TECHNICAL SPECIFICATION CHANGE REQUEST NO. 97

Replace pages 2-5, 2-6, 2-7, B2-4, B2-5, 3/4 3-2 and 3/4 3-3 of Appendix A with the replacement pages provided.

This change will allow operation of Crystal River Unit 3 during Cycle IV, at power levels up to 2300 MWt without an RPS trip based on Reactor Coolant Pump Power Monitors (RCPPM's). This change requires that the trip setpoints for Nuclear Overpower, based on RCS Flow and Axial Power Imbalance, be reduced to provide DNBR protection previously provided by RCPMP's. The enclosed revision to Figure 2.2-1 reflects these reductions. In addition, the Integrated Control System (ICS) must be limited to 92.41% of Rated Thermal Power and the Nuclear Overpower Trip setpoint will be reduced to 94.8% Rated Thermal Power. The latter two changes will (a) prevent the ICS from driving reactor power beyond transient envelope assumptions, and (b) provide trips, on increasing flux, in time frames consistent with the original Cycle IV analyses for Full Power operation.

FIGURE 2.2-1

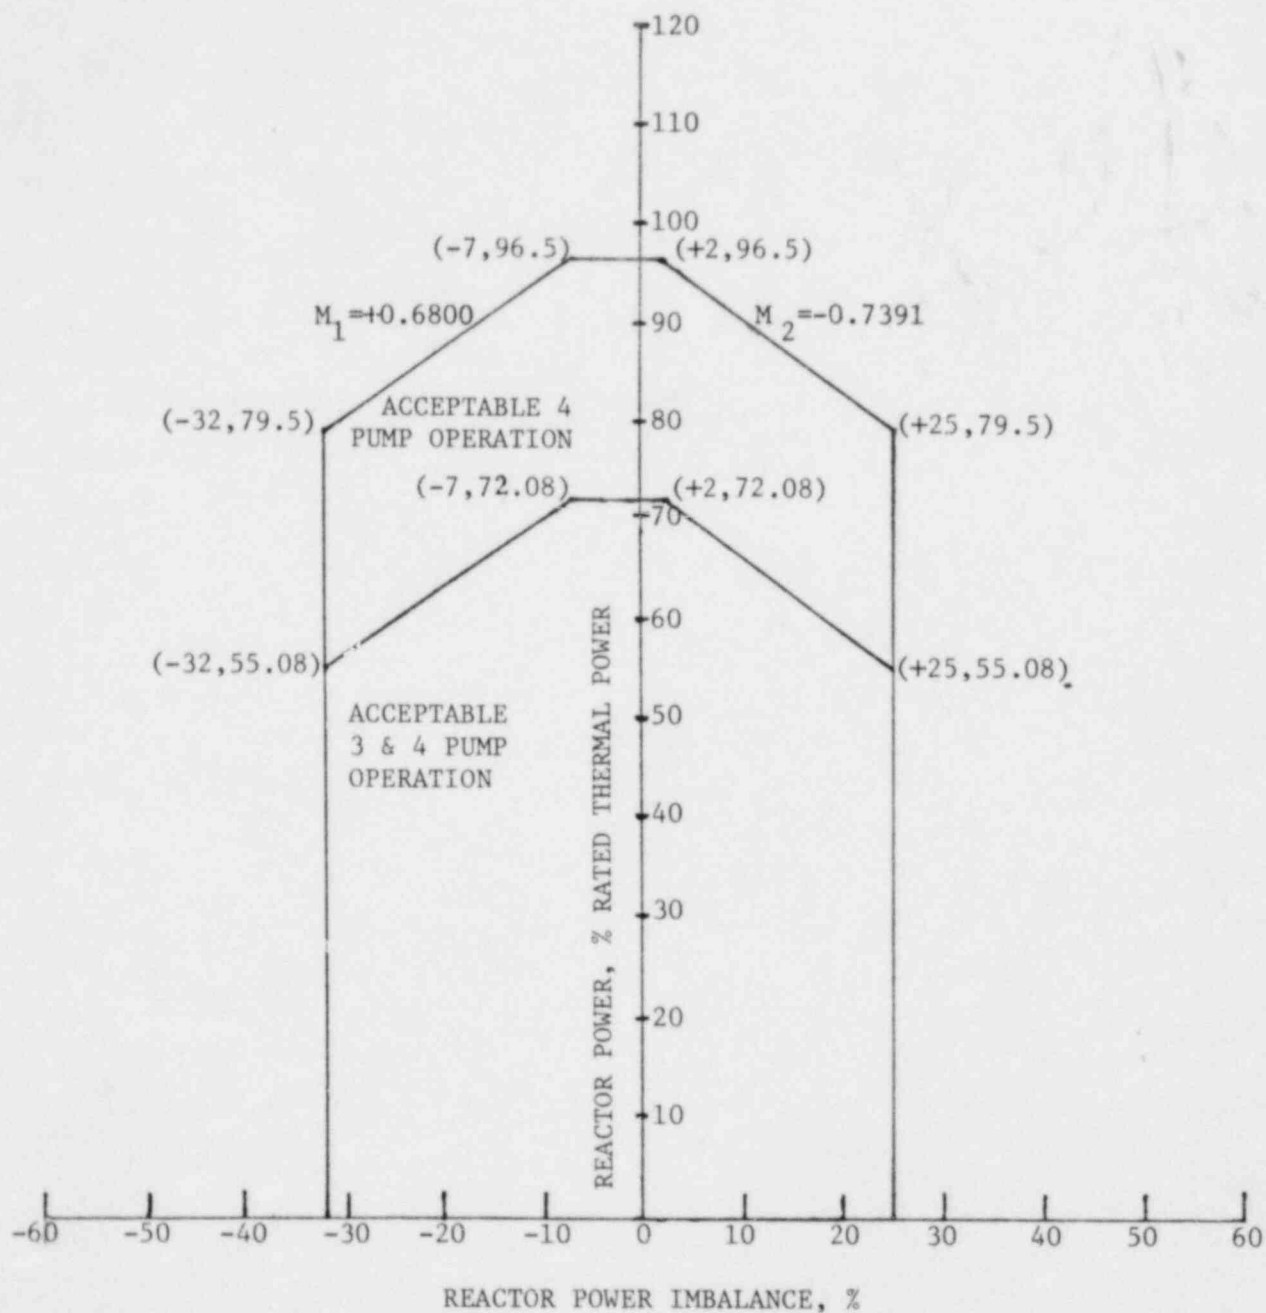
The power level trip setpoint produced by the reactor coolant system flow is based on a flux-to-flow ratio which has been established to accommodate flow decreasing transients from high power.

The power level trip setpoint produced by the power-to-flow ratio provides both high power level and low flow protection in the event the reactor power level increases or the reactor coolant flow rate decreases. The power level setpoint produced by the power-to-flow ratio provides overpower DNB protection for all modes of pump operation. For every flow rate there is a maximum permissible power level, and for every power level there is a minimum permissible low flow rate. Typical power level and low flow rate combinations for the pump situations of Table 2.2-1 are as follows:

1. Trip would occur when four reactor coolant pumps are operating if power is $\geq 96.5\%$ and reactor flow rate is 100%, or flow rate is $\leq 93.69\%$ and power level is 90.41%.
2. Trip would occur when three reactor coolant pumps are operating if power is $\geq 72.08\%$ and reactor flow rate is 74.7%, or flow rate is $\leq 70.26\%$ and power is 67.81%.

3. RCS Outlet Temperature - High	$\leq 618^{\circ}\text{F}$	$\leq 618^{\circ}\text{F}$
4. Nuclear Overpower Based on RCS Flow and AXIAL POWER IMBALANCE (1)	Trip Setpoint not to exceed the limit line of Figure 2.2-1	Allowable Values not to exceed the limit line of Figure 2.2-1
